**RAVENSWORTH EAST
RESOURCE RECOVERY
PROJECT**

Response to Submissions

Project Director: **Michelle Kirkman**
Project Manager: **Tim Browne**
Report No. **3081/R03/FINAL**
Date: **July 2013**

Figure 1: RERR Mining Progression

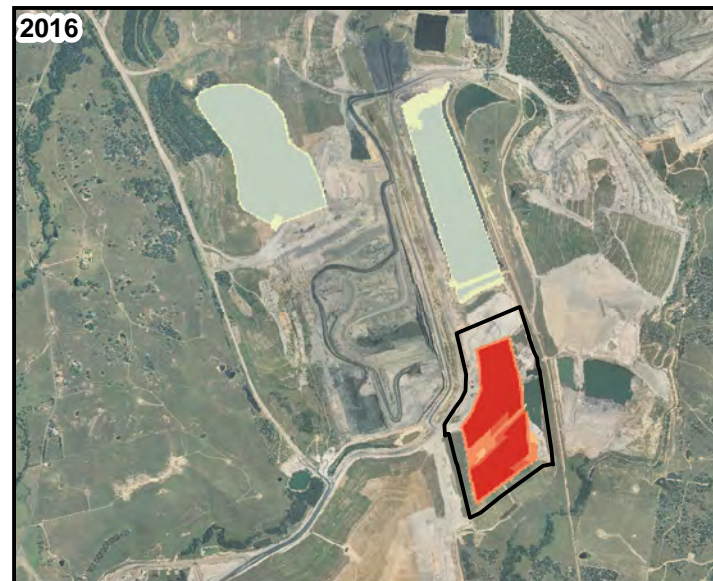
The annual progression of the RERR project simulated for the Proposed case scenario is shown in **Figure 1**. The mining progression is shown as the incremental change in surface elevation for each year, or the elevation at the end of the year less the elevation at the start of that year. **Figure 1** shows the yearly progression of the RERR mining area, with the pit deepening between 10 m to more than 30 m per year in subsequent mining years. Drain cells within the vertical layers of the model were progressively switched on according to the years shown in **Figure 1** to simulate the deepening of the TP2 pit under the proposed modification.

Figure 5: Overburden Drawdown at 2016

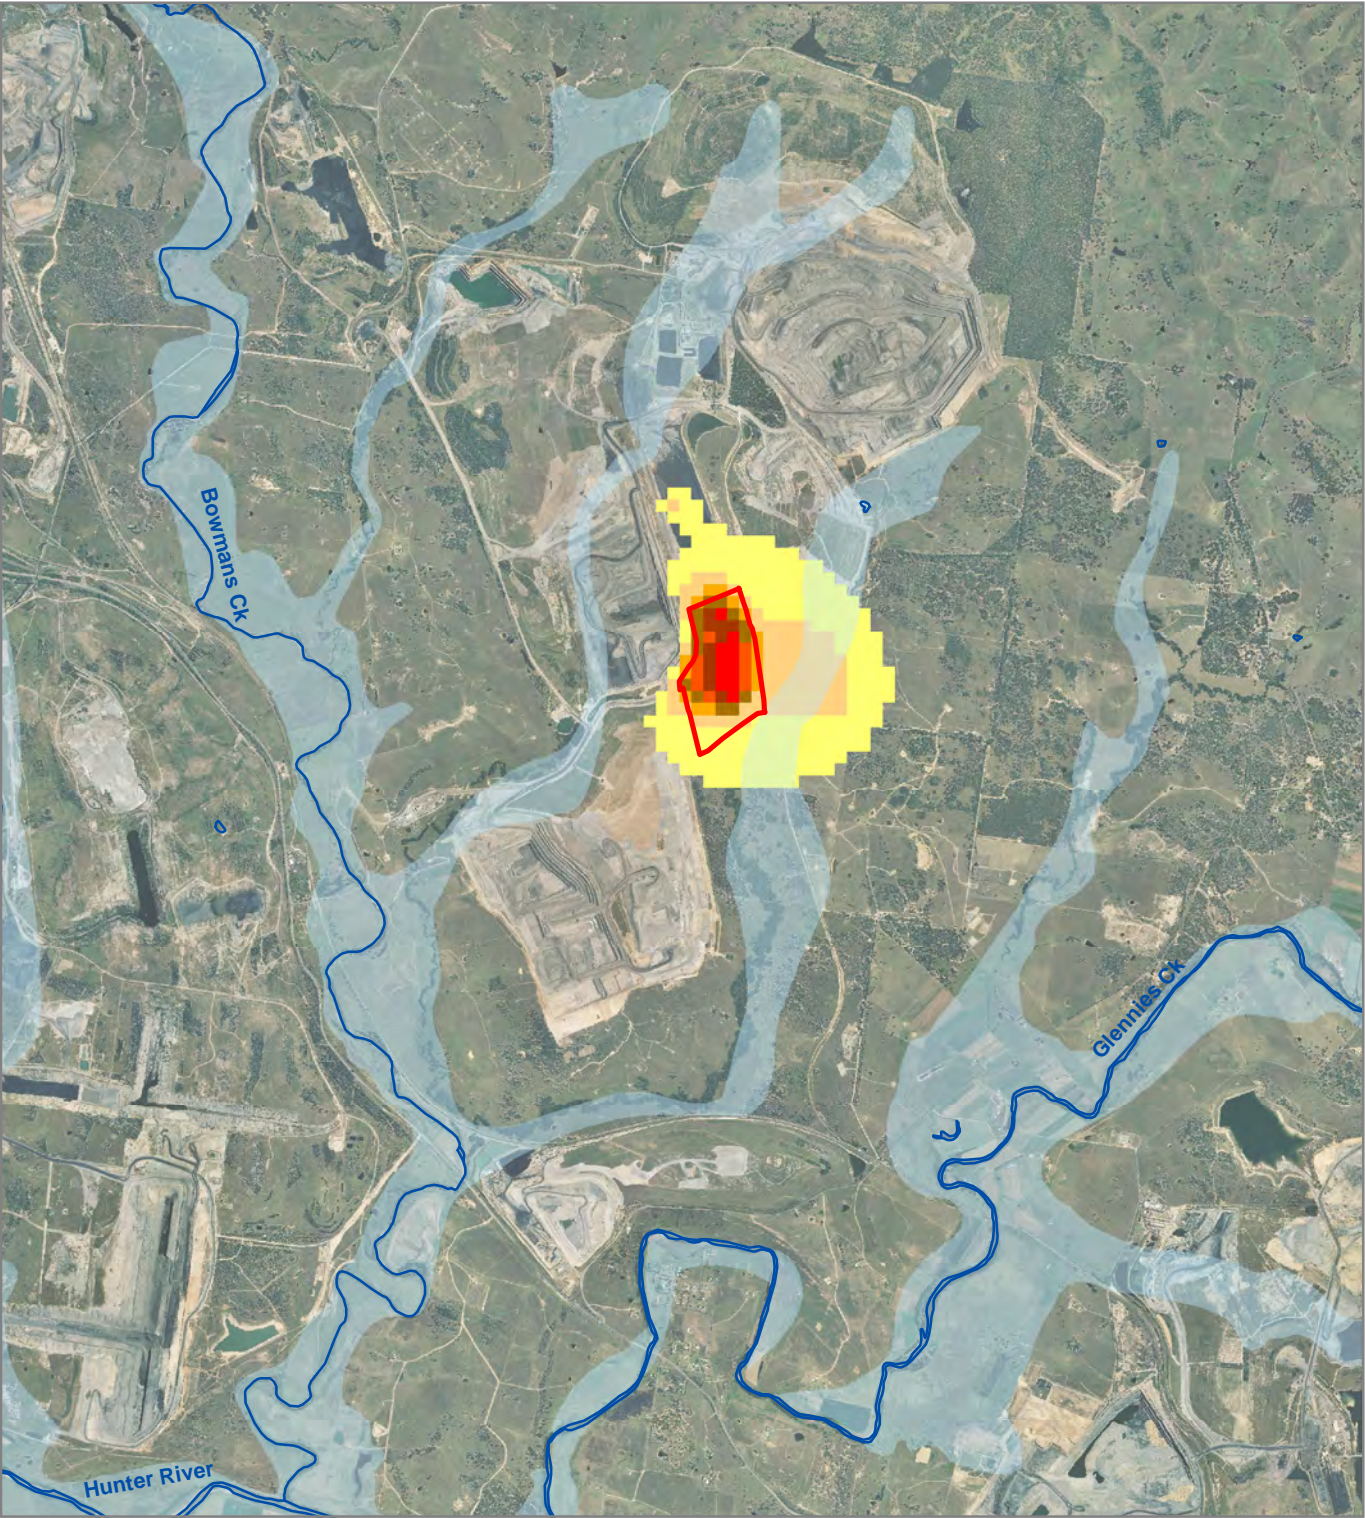
Clarify the volumes and timing of modelled peak contributions from the Hunter Unregulated Alluvium, Bowmans Creek Water Source and Glennies Creek Water Source

As discussed in **Section 2.7.5.2**, the model results for predicted drawdown in the alluvial aquifers and the predicted drawdown for the hard rock aquifers are shown in Figures 2 to 10 in **Appendix 2**. As discussed previously, Figures 2 to 4 in **Appendix 2** replace Figure 5-2 and Figures 5 to 10 replace figure 5-1 in the RERR Groundwater Impact Assessment Report (SKM 2012). The figures have been provided to illustrate the results in increased resolution using a larger format. Figure 5-2 included in the Groundwater Impact Assessment Report (SKM 2012) also incorrectly illustrated modelling results in relation to the predicted alluvial drawdown at the end of modelling. The modelling results are now correctly illustrated in Figure 4 (**Appendix 2**). The results illustrated in Figures 5 to 10 (**Appendix 2**) are consistent with that presented in Figure 5-1 in the RERR Groundwater Impact Assessment Report (2012) and are provided for additional detail only. Figure 11 (**Appendix 2**) is provided to illustrate predicted post mining groundwater levels.

The predictive model results in relation to drawdown in the alluvial aquifers and the predicted drawdown in the hard rock aquifer are illustrated in Figures 2 to 10 in **Appendix 2**. As discussed previously, Figures 2 to 4 (**Appendix 2**) replace Figure 5-2 in the RERR Groundwater Impact Assessment Report (SKM 2012). The revised figures have been provided to illustrate the results in increased resolution and using a larger format. Figure 5-2 included in the Groundwater Impact Assessment Report (SKM 2012) also incorrectly illustrated modelling results in relation to the predicted alluvial drawdown at the end of modelling. The modelling results are now correctly illustrated in Figure 4 (**Appendix 2**). The results illustrated in Figures 5 to 10 (**Appendix 2**) are consistent with that presented in Figure 5-1 in the RERR Groundwater Impact Assessment Report (SKM 2012) and are included to provide additional detail only.

The groundwater model estimates negligible water take or water loss from the alluvial aquifers in the local area as a result of the proposed RERR modification, which is demonstrated by the lack of predicted drawdown shown in **Figures 2** through **4**, at the time of peak inflows into the pit (2016), at the end of current mining consent (2021), and at the end of the modelling period (2120). Based upon these results and the negligible incremental impacts, the cumulative water take from the alluvial sources due to the proposed modification would be no more than that estimated in previous groundwater assessments for the Ravensworth East, Mt Owen and Glendell mines. The groundwater assessment previously undertaken by Mackie Environmental Research (MER) for the original development consent for Ravensworth East in 1998 (MER, 1998) described 'minimal' opportunity for downward leakage as a result of mining activities.

Figure 11: Water Table at 2120 (m AHD)

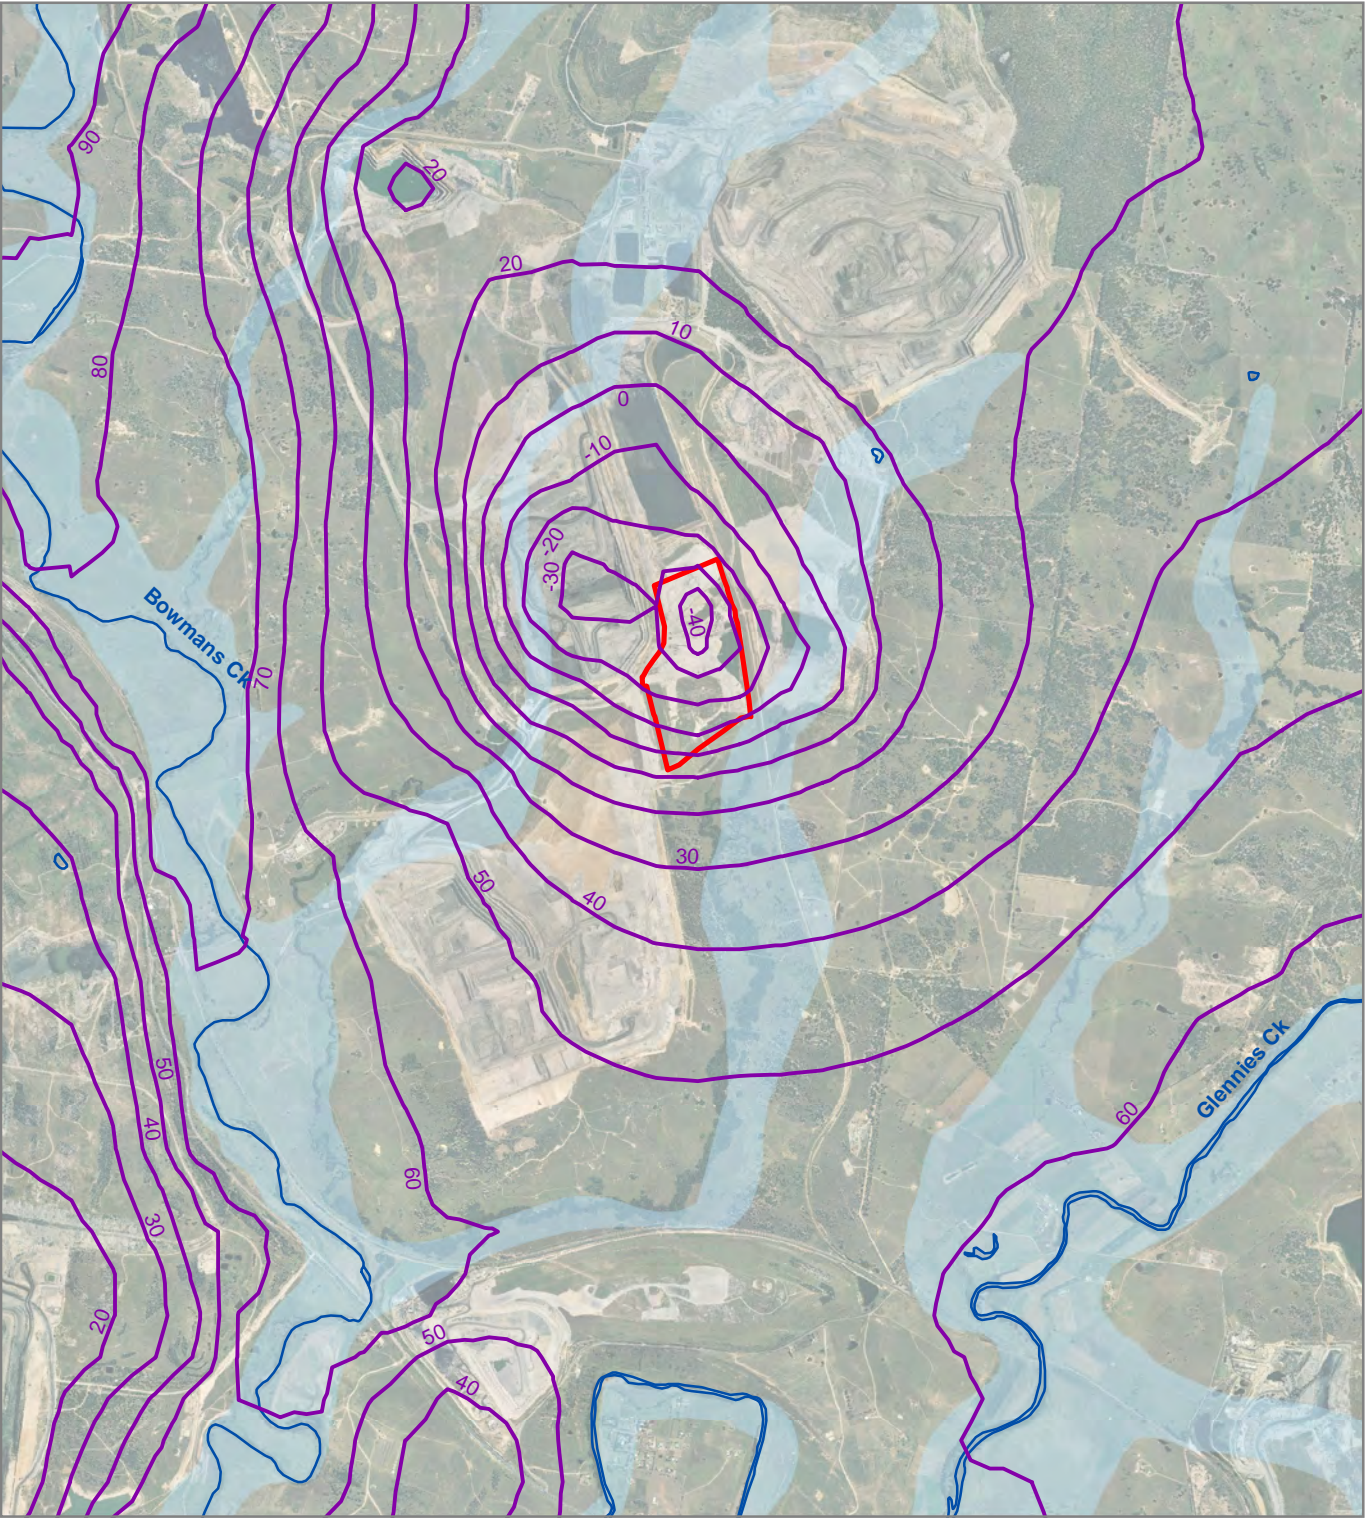
2.6.5.4 Provide additional information in Appendix A of the SKM report to allow complete assessment of the groundwater model construction and performance, including:

As discussed in **Section 2.7.5.3**, the peak groundwater take (estimated as the combined peak pit inflow for the RERR mining area and West Pit) is predicted to be 770 ML/year in 2014. The estimated post mining groundwater levels are illustrated in Figure 11 (**Appendix 2**).

are calculated as the difference between the Proposed case and Base case scenarios. Under the Base case, the lack of a deep void allows recovery of water levels after the cessation of mining activities from neighbouring operations. In the Proposed case, the final void will result in equilibrium potentiometric heads of approximately -40 m AHD in this area of the void as shown in **Figure 11**.
